**ADDENDUM NO. 1**

# CANADA COLLEGE TENNIS FACILITY IMPROVEMENTS ADDENDUM ONE

**CANADA COLLEGE TENNIS FACILITY IMPROVEMENTS**

**DA2**

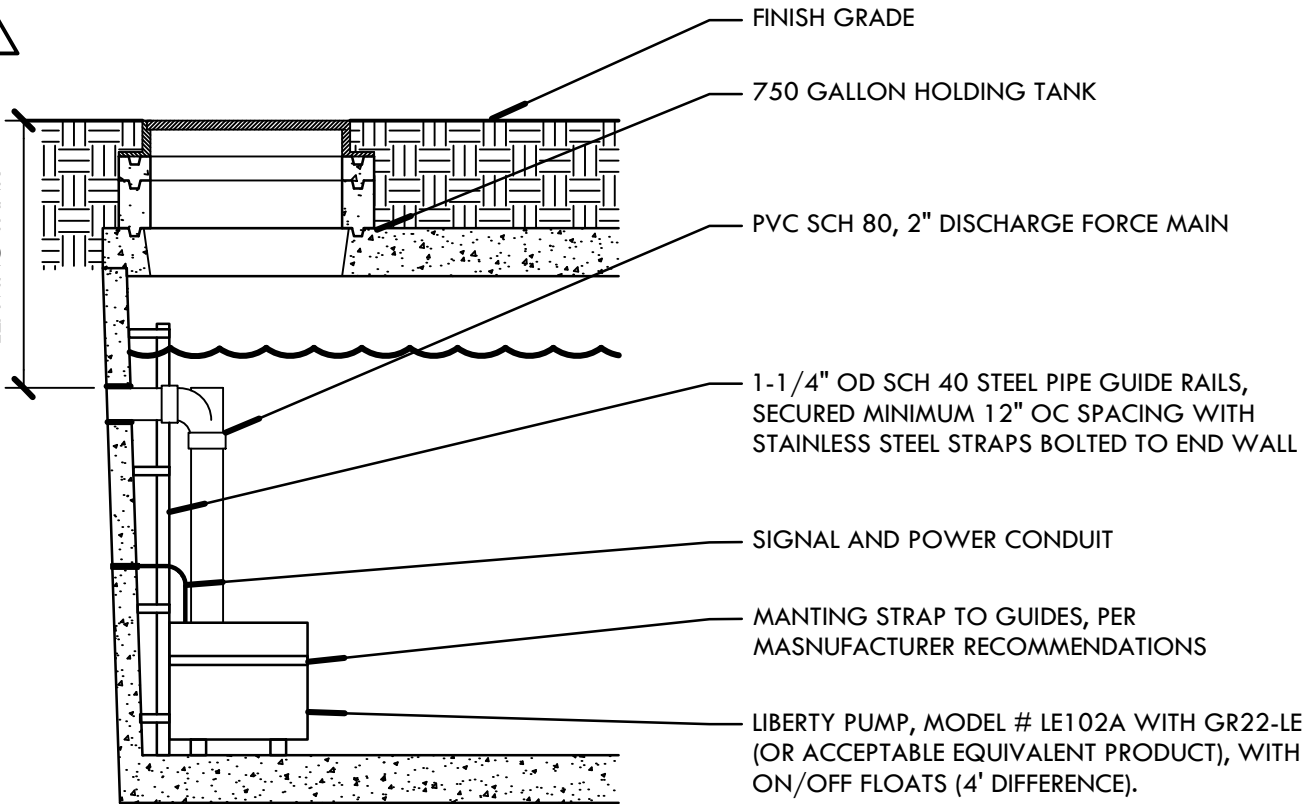
2.	D2.0	<p>a.) Added new Pump Assembly detail for holding tank. Refer to attached Drawing Attachment DA2.</p> <p>b.) Added new Holding Tank detail. Refer to attached Drawing Attachment DA3.</p>

**DA4**

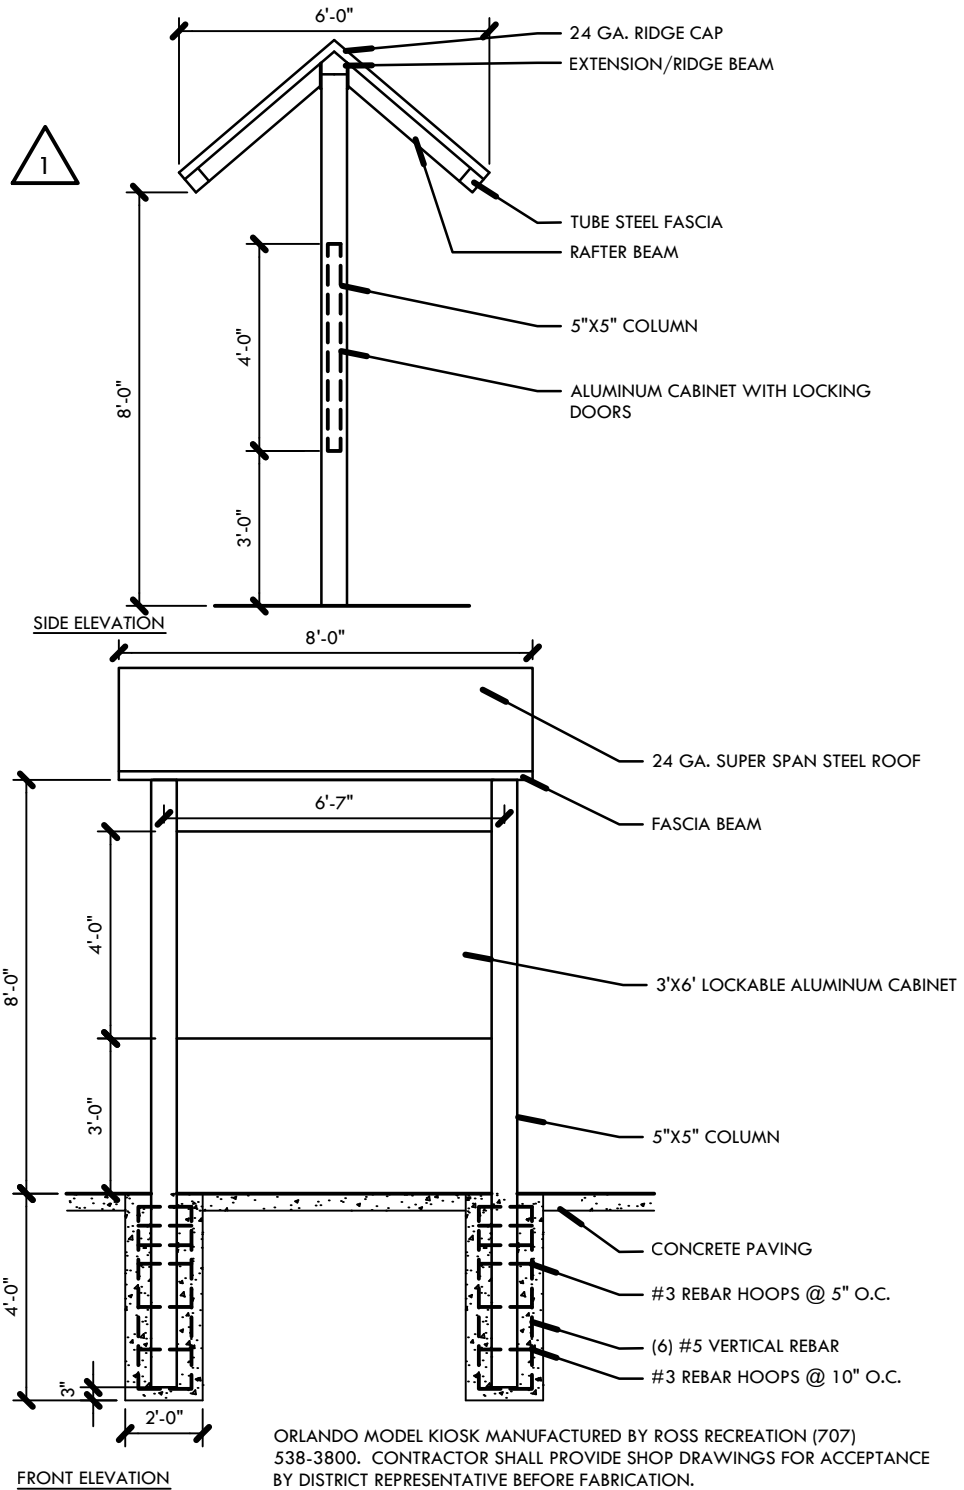
3.	D3.0	<p>a.) Revised Kiosk detail. Refer to attached Drawing Attachment DA4.</p> <p>b.) Added new Thrust Block detail. Refer to attached Drawing Attachment DA5.</p>

1 **PARTIAL ELECTRICAL FLOOR PLAN**

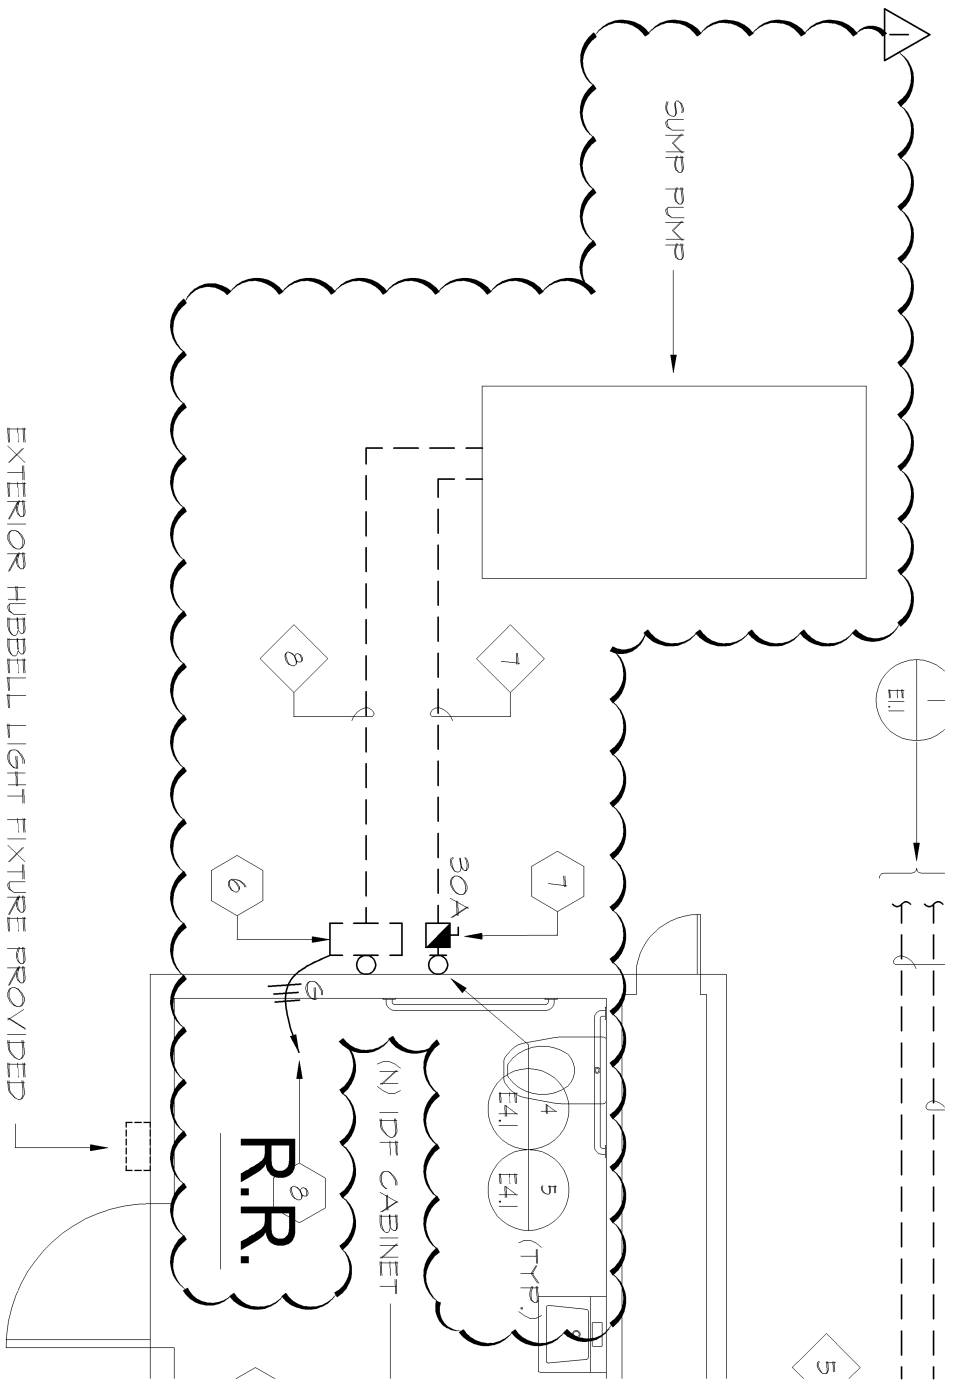
6.	E1.2	Revised photometrics floor plan. See attached E7 Drawing.
7.	E2.1	<p>a.) Revised electrical floor plan. See attached E3 Drawing.</p> <p>b.) Revised electrical floor plan. See attached E4 Drawing.</p> <p>c.) Revised sheet note #3. Added sheet note #6, 7, 8. Revised conduit schedule note #4. Added conduit schedule note #7, 8. See attached E5 Drawing.</p>

**1 SURVEILLANCE SYSTEM RISER DIAGRAM**

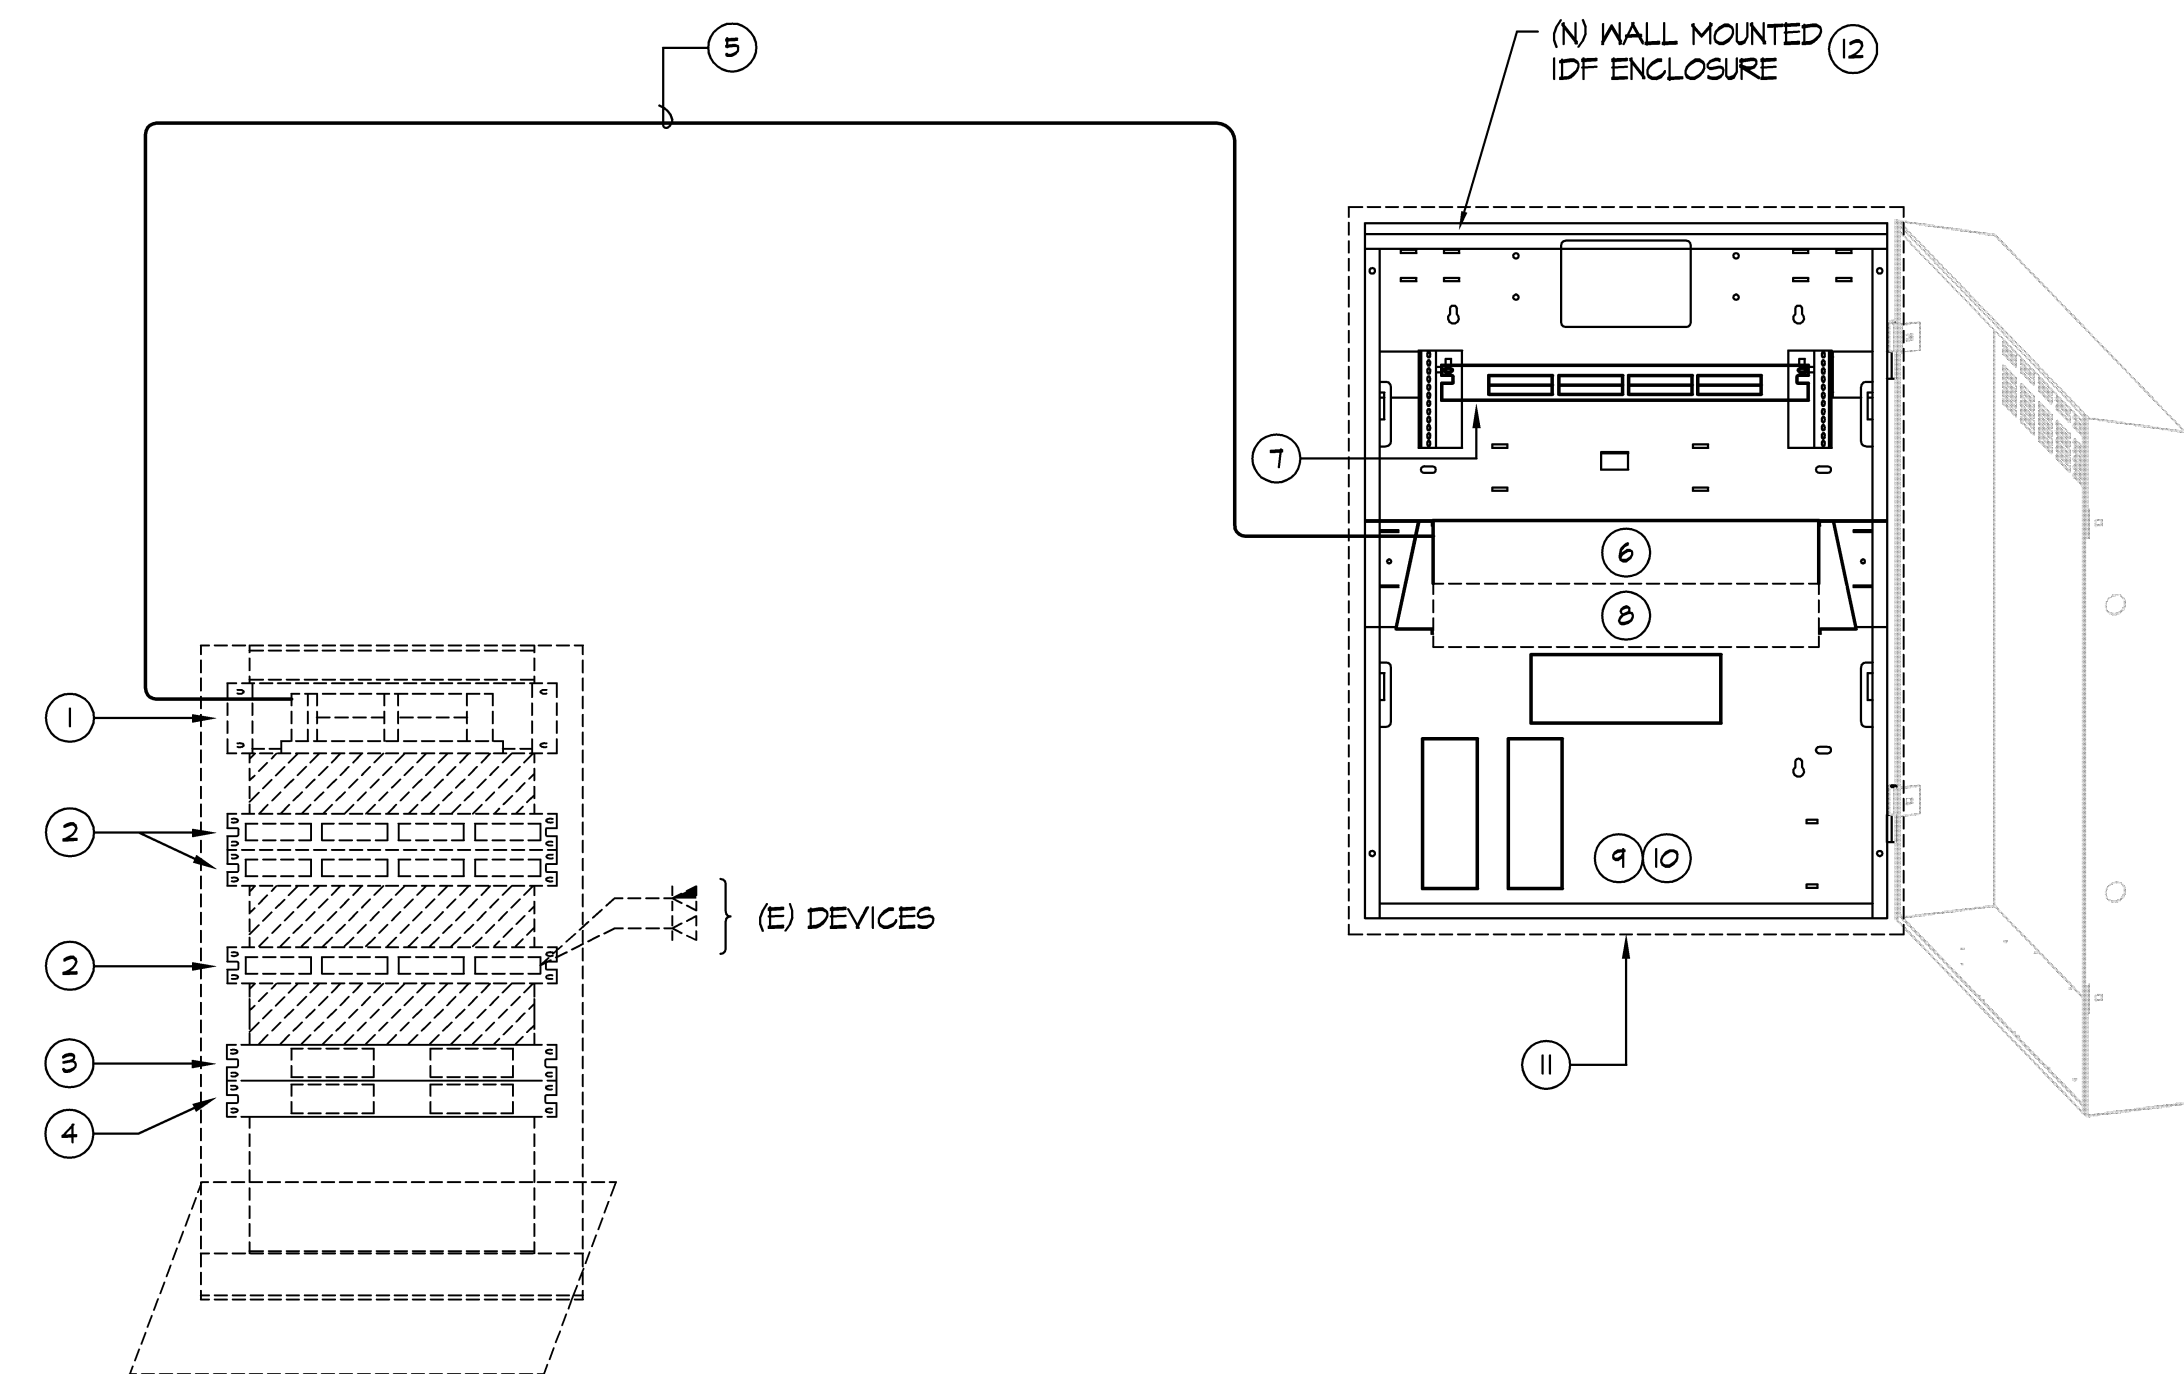
8.	E3.2	1. Revised Surveillance System Riser Diagram 1/E3.2. See attached E6 Drawing.
9.	L-4.0	1. NOTE #16 CALLOUT FOR TENNIS BALL RACKS IS TO BE DELETED.
